SUBJECT: NEW ORCHARD FARM ELEMENTARY SCHOOL  
ORCHARD FARM R-V SCHOOL DISTRICT  
ST. CHARLES, MISSOURI  
PROJECT # 23-09B

Enclosed please find one (1) electronic .pdf copy of Addendum No. 2, dated August 1, 2024, for the above-named project.

ORCHARD FARM R-V SCHOOL DISTRICT  
NEW ELEMENTARY SCHOOL  
ST. CHARLES, MISSOURI

1  
M3.2  
**MEZZANINE DUCT ROUTING ELEVATION**  
SCALE: 1/4" = 1'-0"

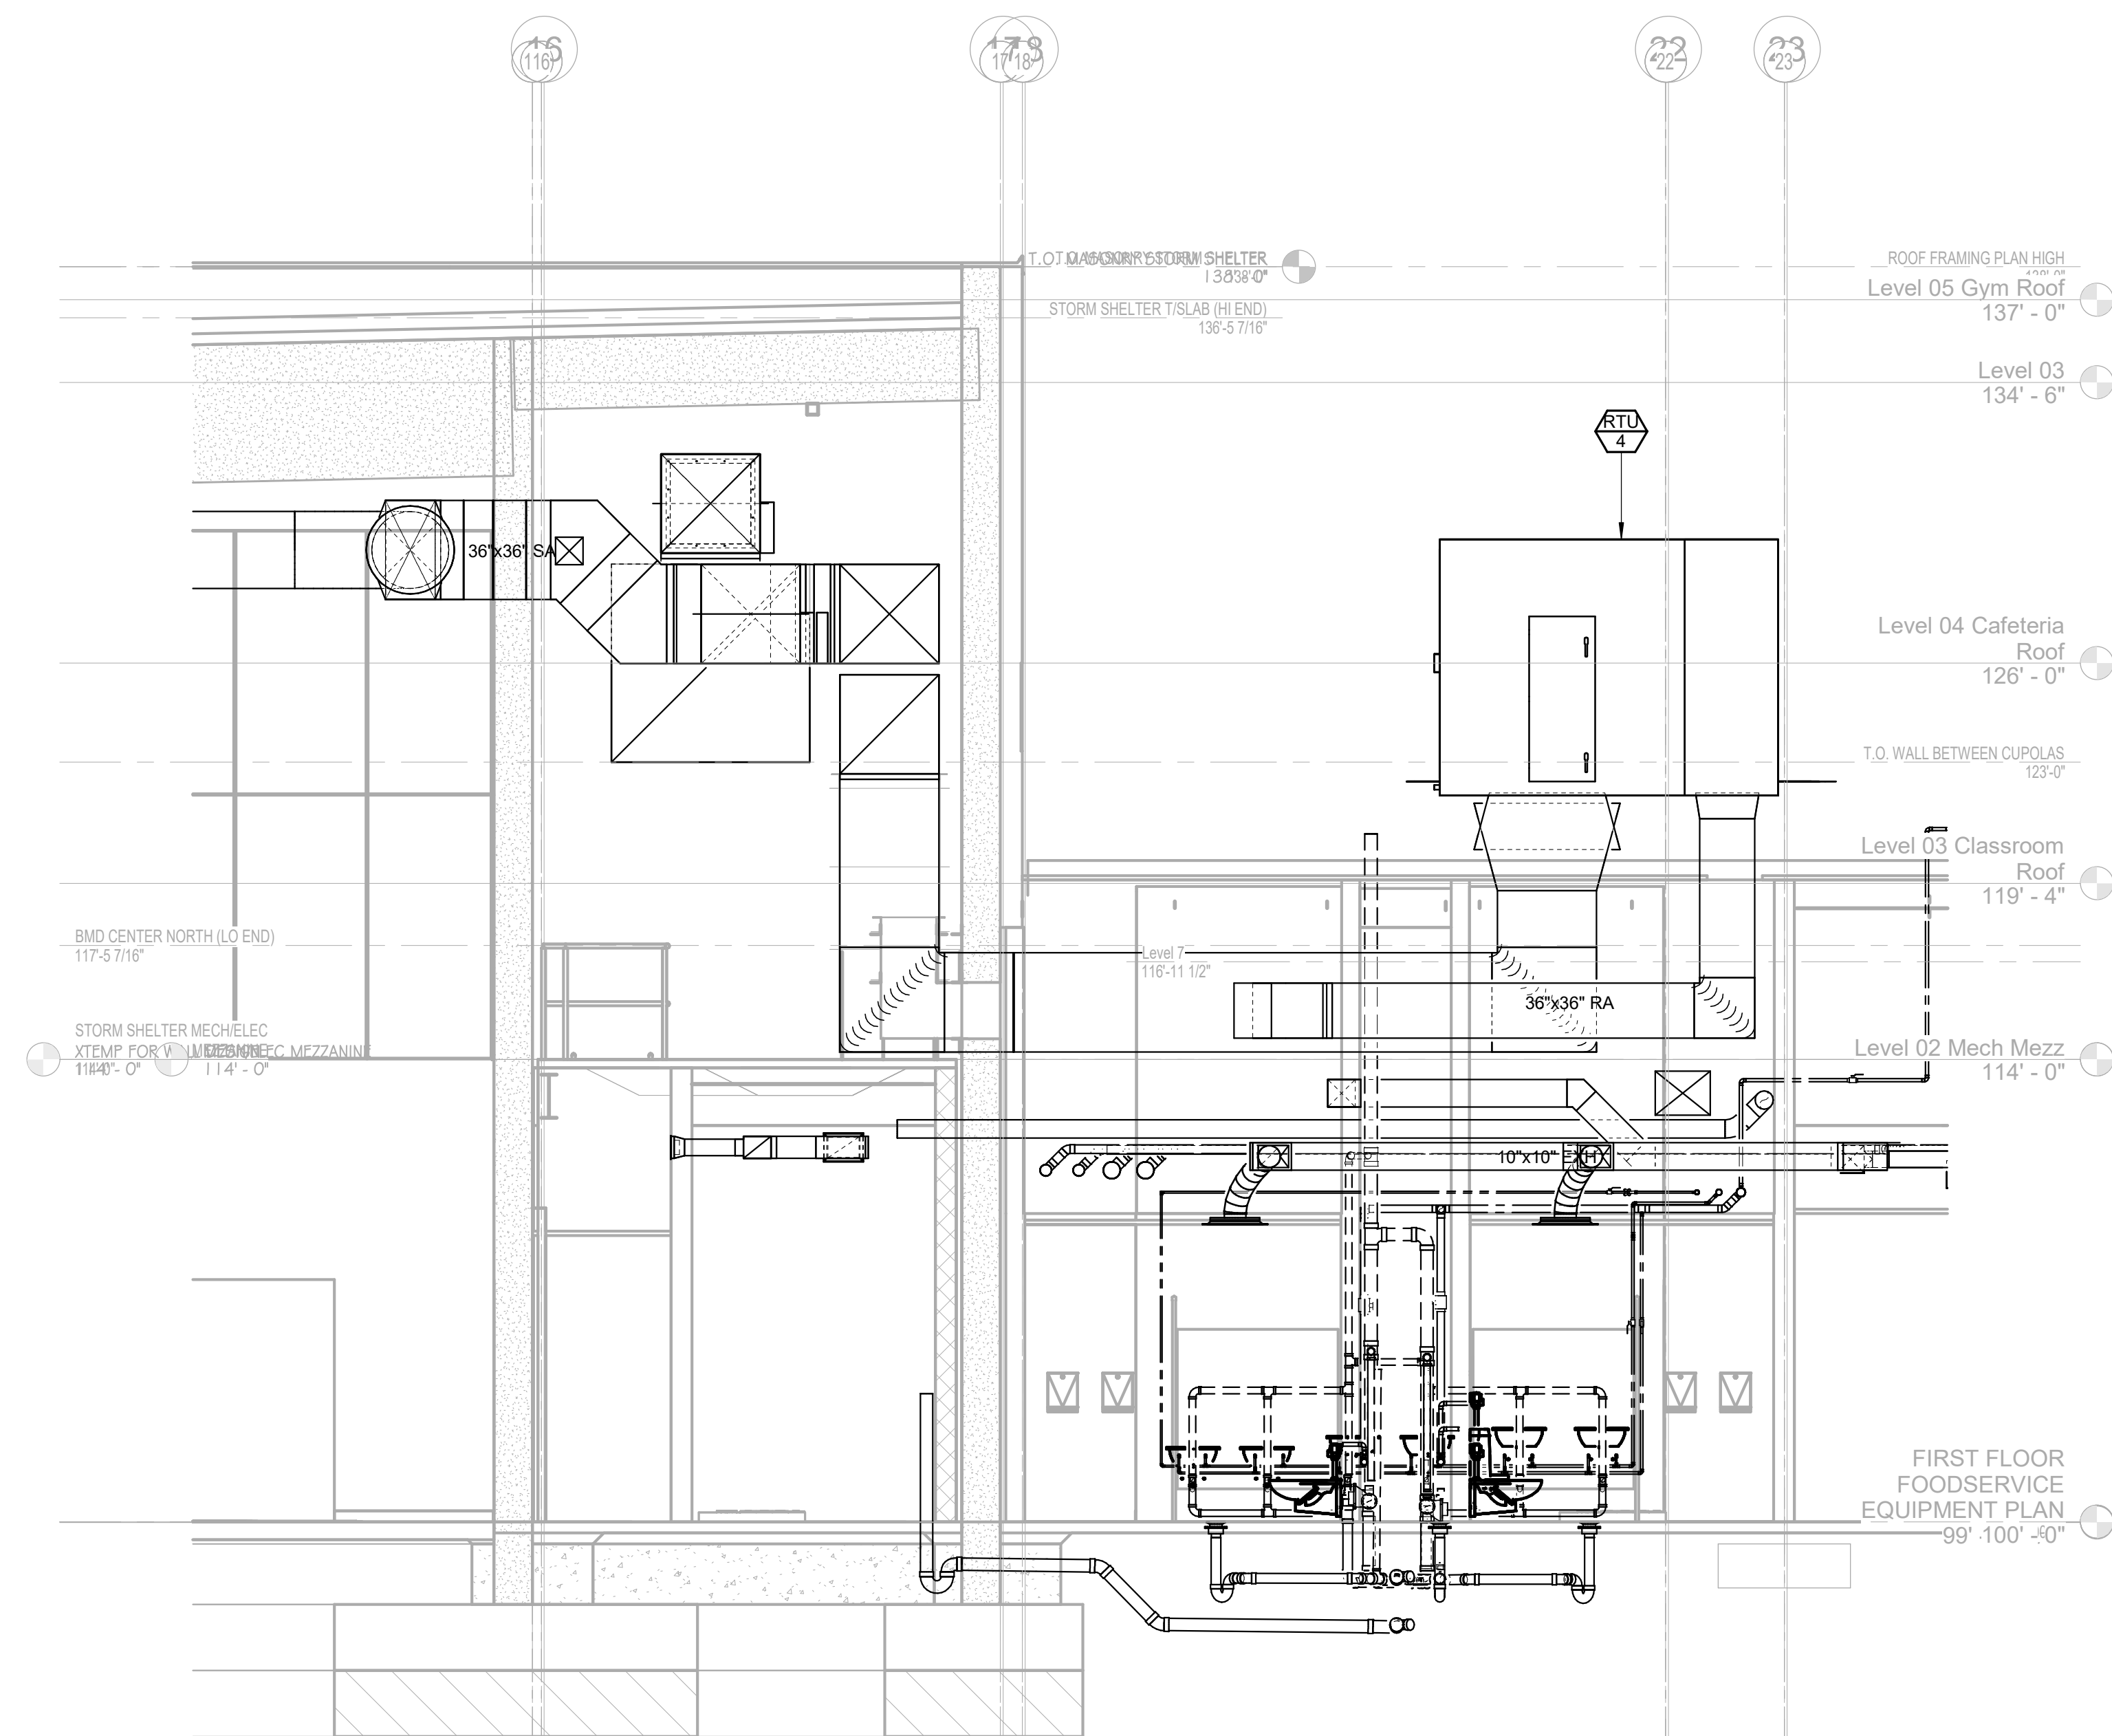
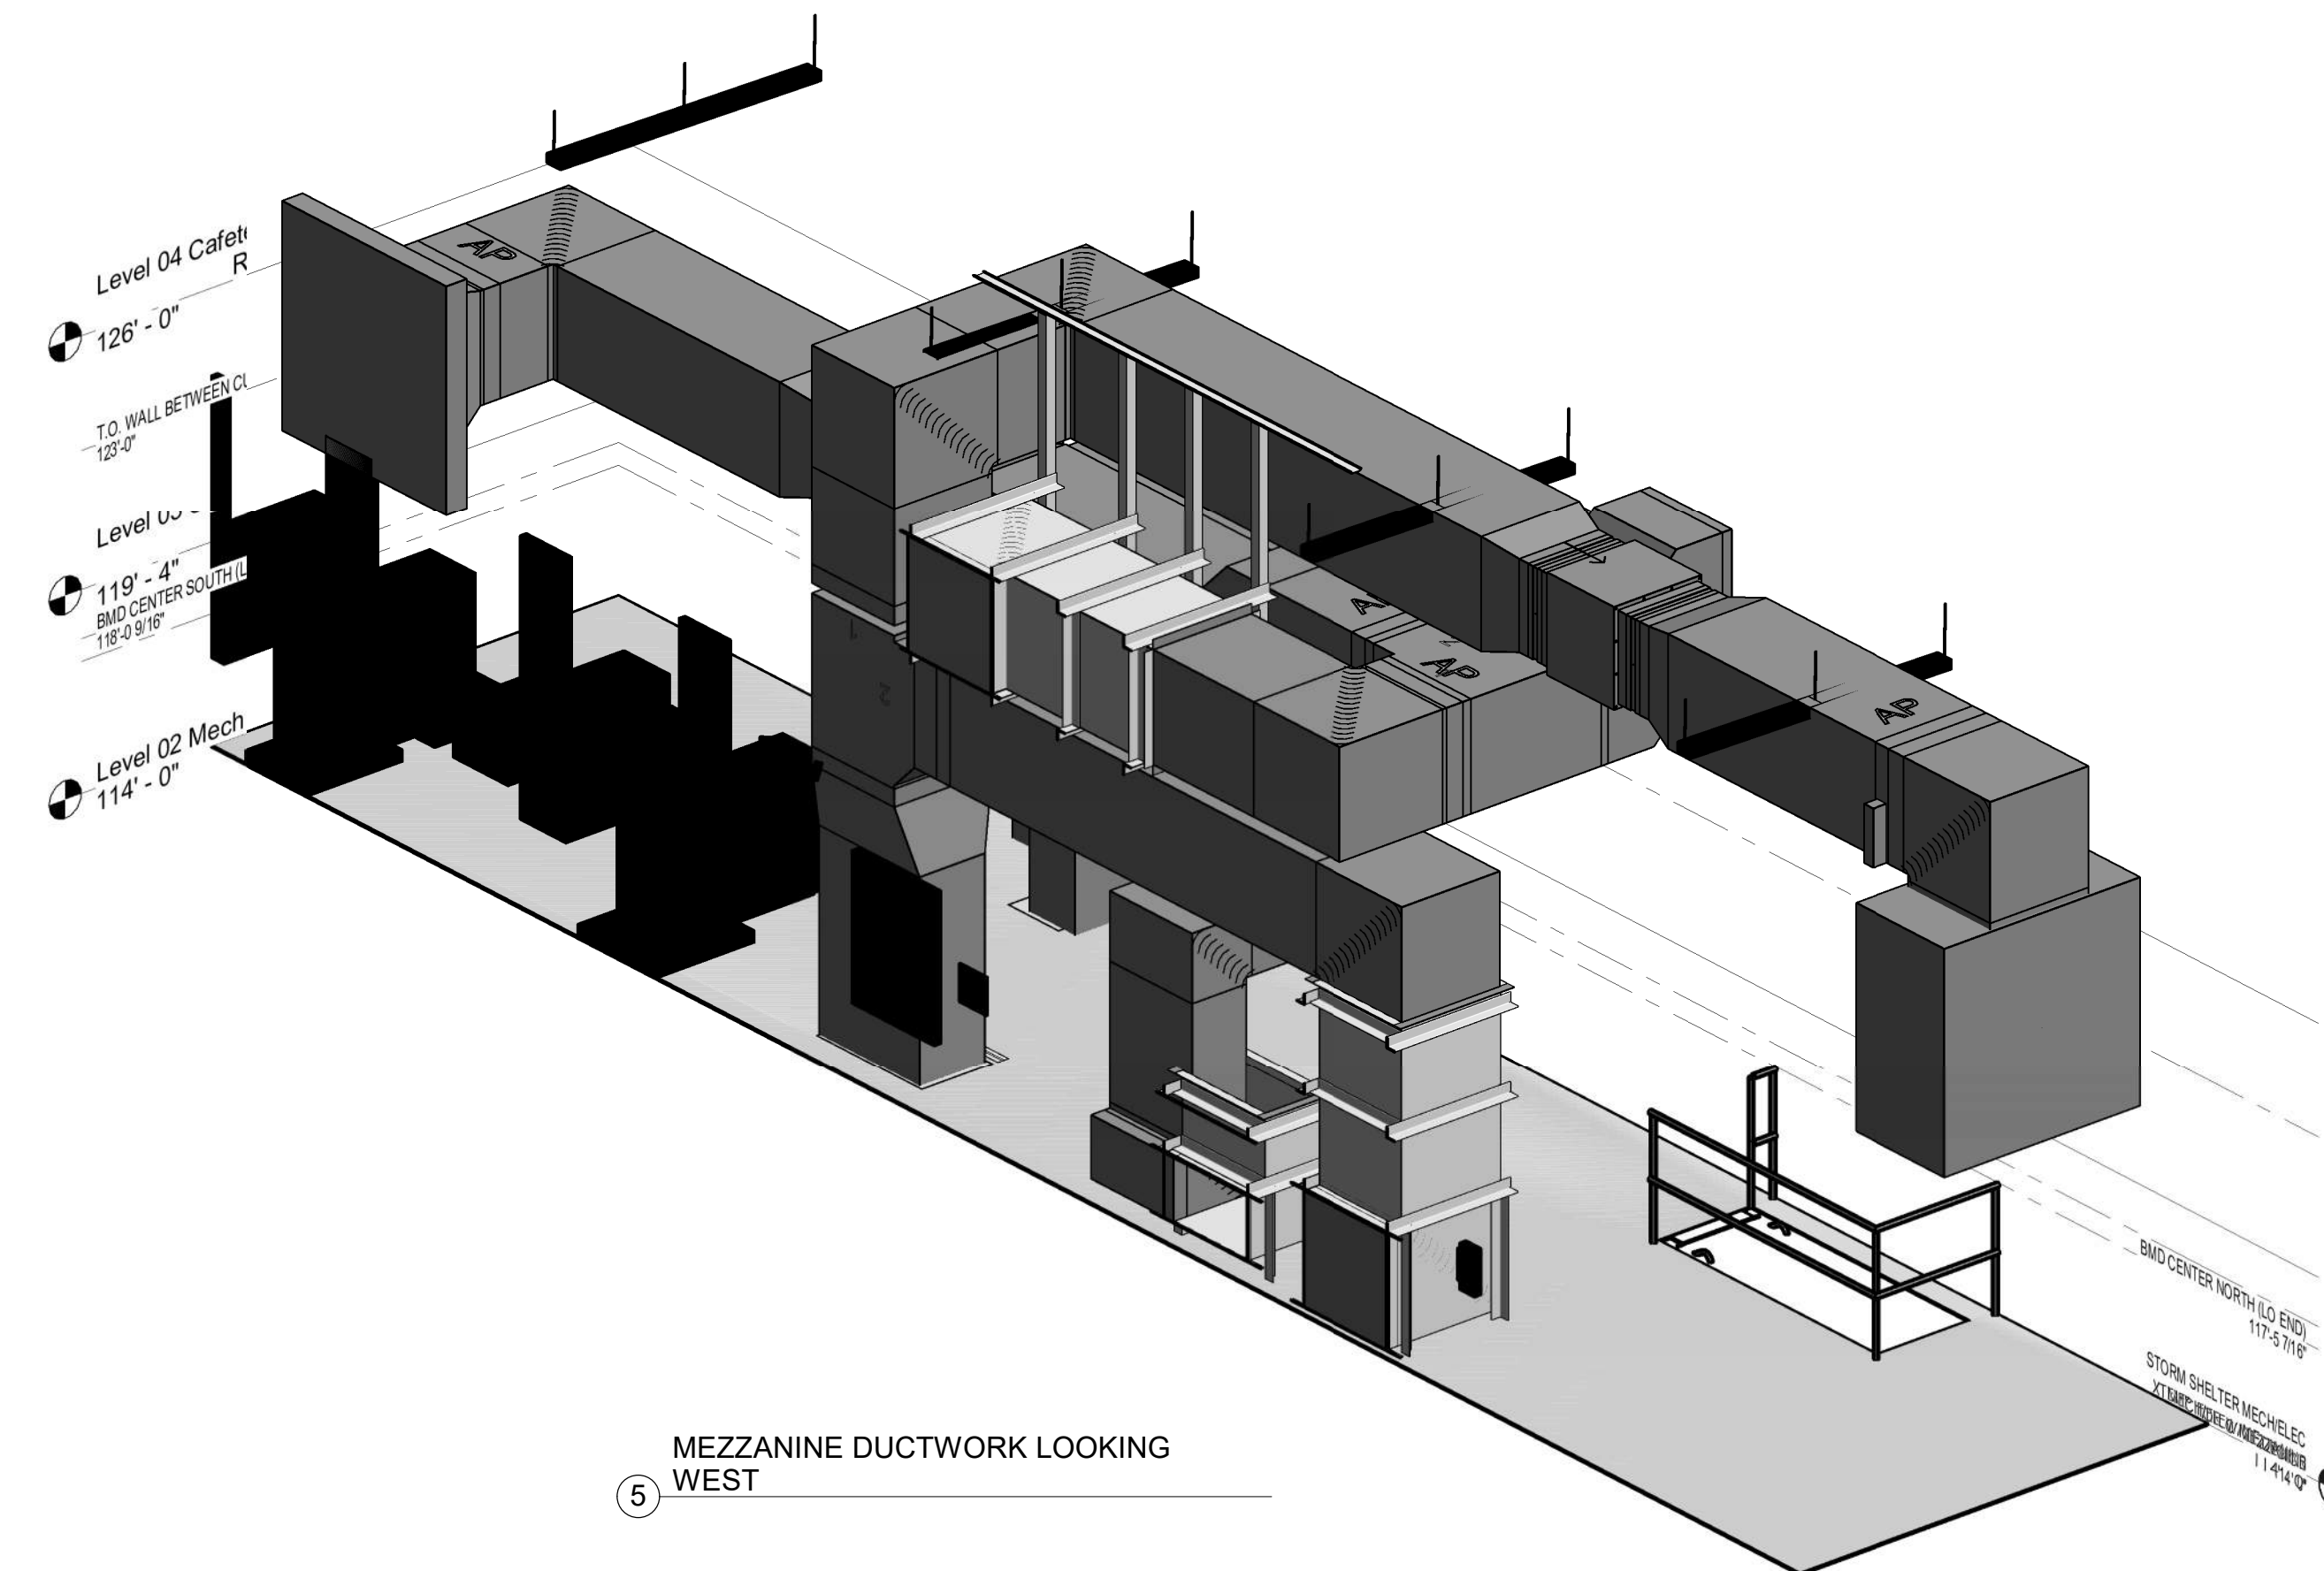
ITEM NO. 19 – MECHANICAL DRAWING SHEET M3.2

- A. **“REVISE”** Storm Duct in Mezzanine.
- B. **“REVISE”** Note 2 to be for 50 cfm.
- C. **“REVISE”** Supply air duct sizes to Mech Office 303 and DZ Office 321
- D. **“REVISE”** RTU-4 Return air duct.
